# Analyses of Groundwater Flow, Contaminant Fate and Transport, and Distribution of Drinking Water at Tarawa Terrace and Vicinity, U.S. Marine Corps Base Camp Lejeune, North Carolina: Historical Reconstruction and Present-Day Conditions

## Response to the Department of the Navy's Letter on: Assessment of ATSDR Water Modeling for Tarawa Terrace

## **RESPONSE TO THE DEPARTMENT OF THE NAVY'S LETTER ON ASSESSMENT OF ATSDR WATER MODELING FOR TARAWA TERRACE**

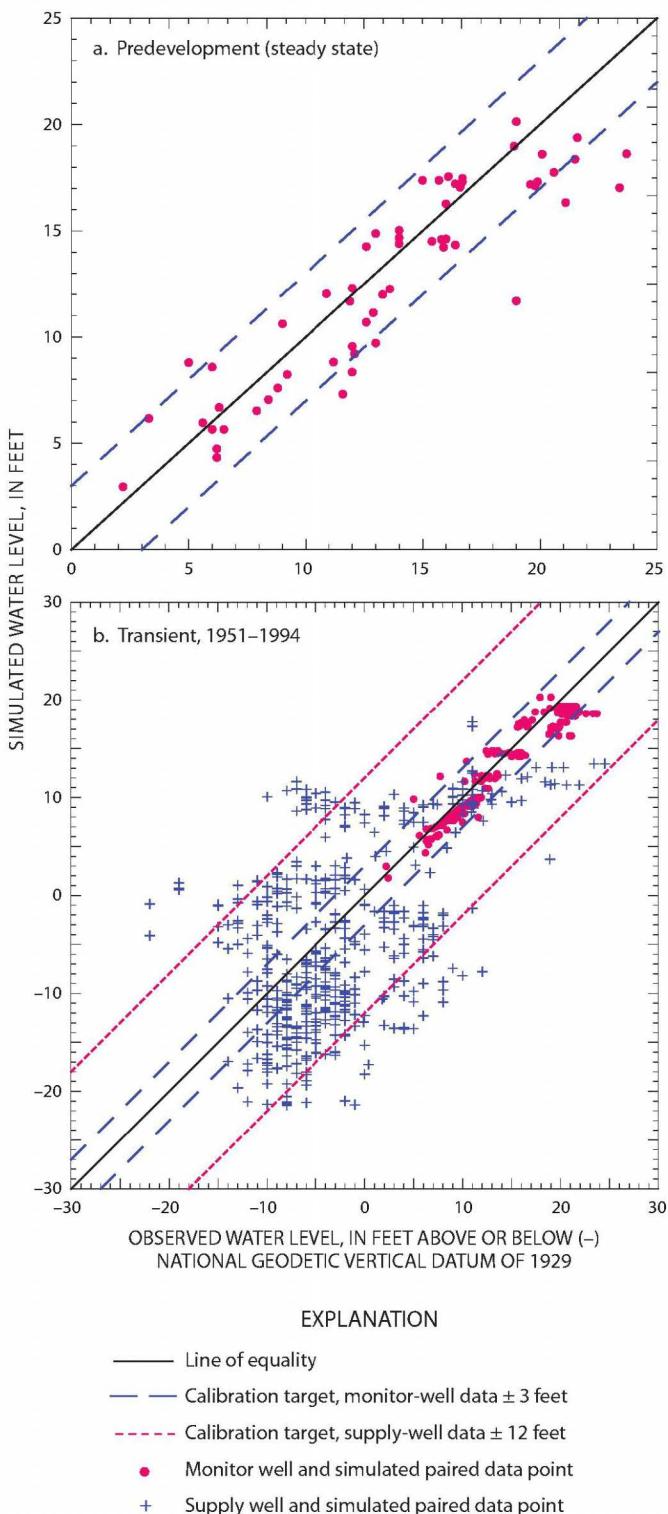
*For Tarawa Terrace groundwater, the difference between observed and simulated elevations is 5 to 10 feet at many times during the 1970's and 1980's. This is a significant disparity because the total change in groundwater elevation from the source area to the receptor wells is approximately 10 to 12 feet.*

This DON approach to evaluating model calibration applies a generalized “rule of thumb” to the Tarawa Terrace groundwater-flow models and is possibly based on wording found in ASTM Guide D5981-96, Standard Guide for Calibrating a Ground-Water Flow Model Application, (ASTM 1996, section 6.4.1): “*the acceptable residual should be a small fraction of the difference between the highest and lowest heads across the site.*” ATSDR is not in agreement with this approach to evaluate model calibration. A careful review of ASTM D5981-96 in its entirety indicates that the DON’s comment, as stated, is totally removed from the context of Section 6 of the ASTM Standard Guide as well as the context of the accuracy of field data used to calibrate the Tarawa Terrace groundwater-flow model, as described in the Chapter C report (Faye and Valenzuela 2007). For example, in Section 6.4, ASTM D5981-96 states: “*the magnitude of the acceptable residual depends partly upon the magnitude of the error of the measurement or the estimate of the calibration target and partly upon the degree of accuracy and precision required of the model’s prediction.*” Furthermore, Note 2 of ASTM D5981-96 states: “*Acceptable residuals may differ for different hydraulic head calibration targets within a particular model. This may be due to different errors in measurement.*” The Tarawa Terrace Chapter C report (Faye and Valenzuela 2007, p. C24) provides a comprehensive discussion of water-level measurement errors arising from the use of airlines and pressure gages to measure water levels. Faye and Valenzuela also point out that this is consistent with the discussions of LeGrand (1959) who described problems associated with the use of airlines to measure water levels at Camp Lejeune as far back as 1959. As pointed out in Faye and Valenzuela (2007, p. C24): “*Typically, reported water levels [at supply wells] vary in excess of 20 ft during the period of measurement, and frequently 10 ft or more from month to month.... Such variability also may indicate leaking or damaged airlines or pressure gages.*”

Faye and Valenzuela (2007, p. C24) also provide detailed discussions as to the rationale for selecting two calibration target ranges for the transient groundwater-flow model. At wells where water-level measurements were obtained using airlines and pressure gages, the calibration target was selected as an absolute difference of 12 ft between simulated and measured water levels. This target was based on well-known disadvantages of using pressure gages and airlines to obtain accurate water-level measurements. Where water-level measurements were obtained using the more highly accurate tapes and similar devices at monitor wells, the calibration target was selected as an absolute difference of 3 ft between simulated and measured water levels. This target was based on the least accurate of these water-level measurements where topographic maps were used to estimate the altitude of a measuring point.

Evaluating model calibration using the “rule of thumb,” as the DON has suggested, also assumes that no other information is available to determine calibration targets. When information is available, such as direct knowledge of methods of water-level measurements and information characterizing the measurement device(s), the calibration targets should be based on these data, not on a “rule of thumb.” Faye and Valenzuela (2007) provide detailed listings of measured water levels in supply and monitor wells throughout Tarawa Terrace (Appendix C5).

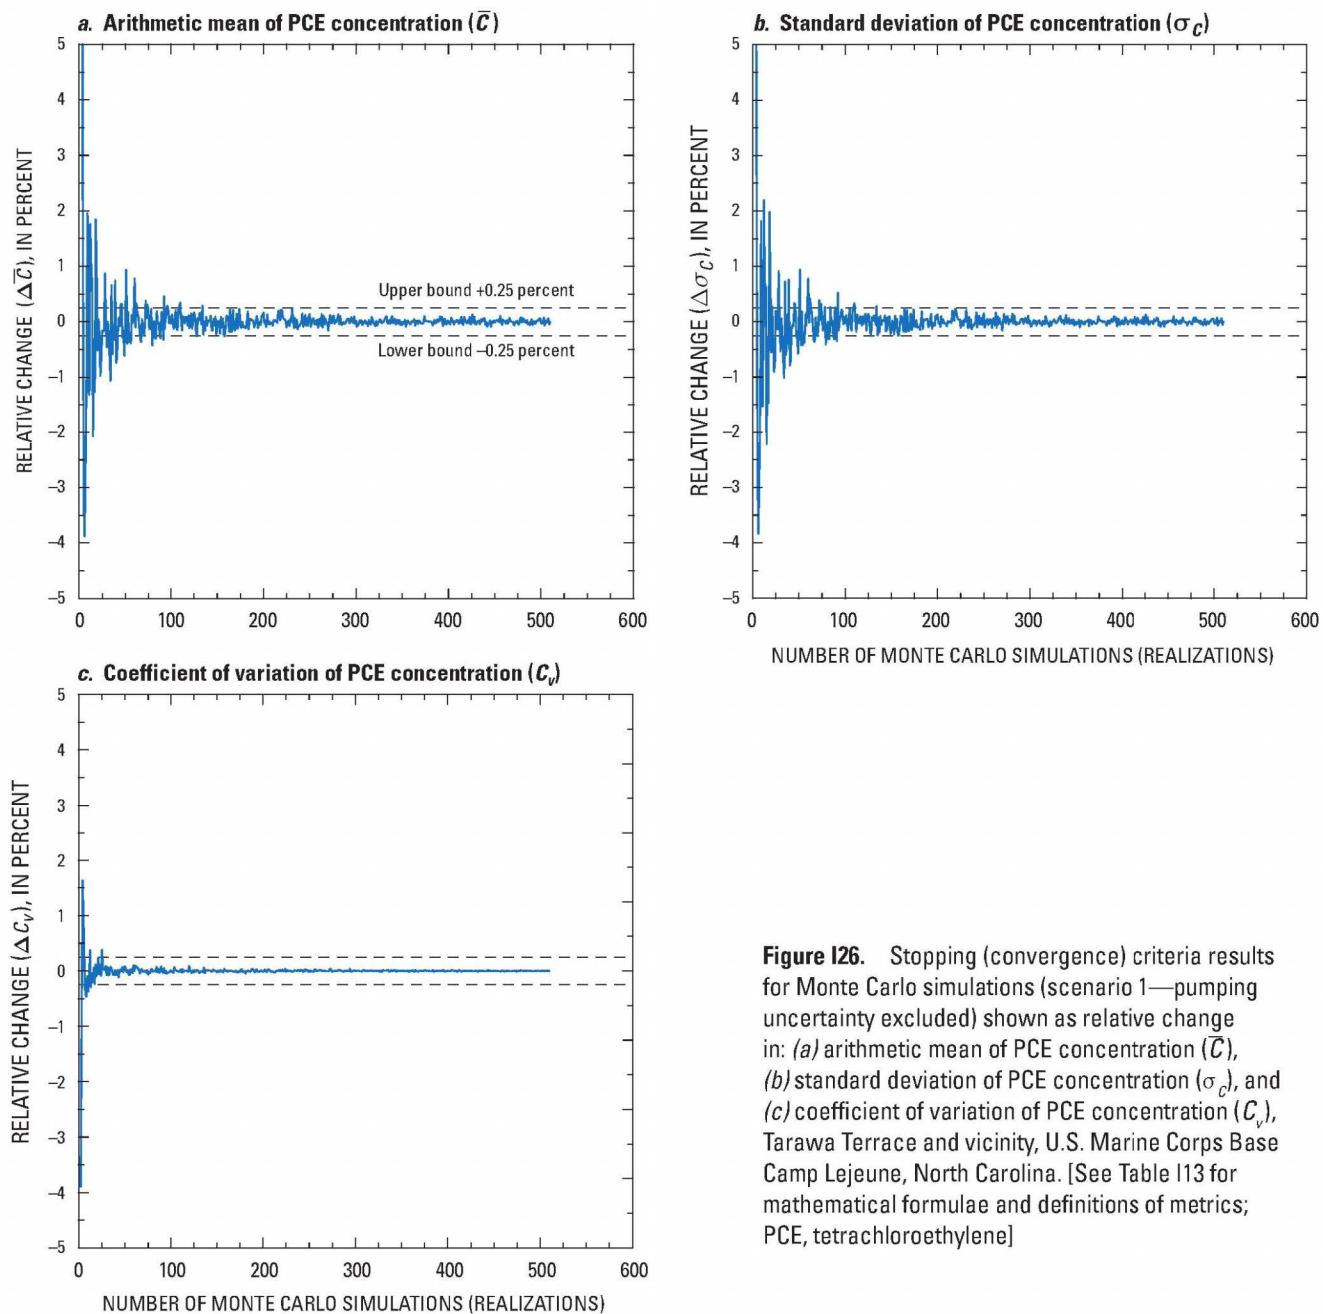
The issue that should be addressed is not how many realizations produced physically plausible solutions, but rather, are the 510 realizations that were successfully produced sufficient to represent an infinite number of random solutions? The metric that determines whether or not this question is answered in the affirmative is the relative change in stopping criteria between successive model simulations. If this relative change is small within a predetermined range, then additional simulations are redundant and do not statistically contribute to an improvement of the representativeness of the overall results with respect to the statistical distributions. The Chapter I report (Maslia et al. 2009) describes in detail the criteria used to determine when a sufficient number of realizations have been achieved. Three stopping criteria were used to halt the Monte Carlo simulation: (1) relative change in the arithmetic mean of PCE concentration in finished water at the Tarawa Terrace WTP,  $\Delta\bar{C}$ ; (2) relative change in the standard deviation of PCE concentration in finished water at the Tarawa Terrace WTP,  $\Delta\sigma_c$ ; and (3) relative change in the coefficient of variation of PCE concentration in finished water at the Tarawa Terrace WTP,  $\Delta C_v$ . Mathematical formulae and definitions of the aforementioned stopping criteria metrics are listed in Table I13 of the Chapter I report (Maslia et al. 2009). In applying the stopping criteria to the Monte Carlo simulations, an upper and lower bound of  $\pm 0.25\%$  was used for each metric. When the computed relative change ( $\Delta\bar{C}$ ,  $\Delta\sigma_c$ , and  $\Delta C_v$ ) was within the aforementioned bounds and the total number of realizations was 500 or more, the Monte Carlo simulation process was halted. Examples of the stopping criteria for each metric are shown graphically in Attachment 8 (Maslia et al. 2009, Figure I26). As can be seen from the stopping criteria, insignificant change (much less than 2.5%) occurs after 300 realizations. Therefore, 510 realizations were more than sufficient to represent an infinite number of random solutions.
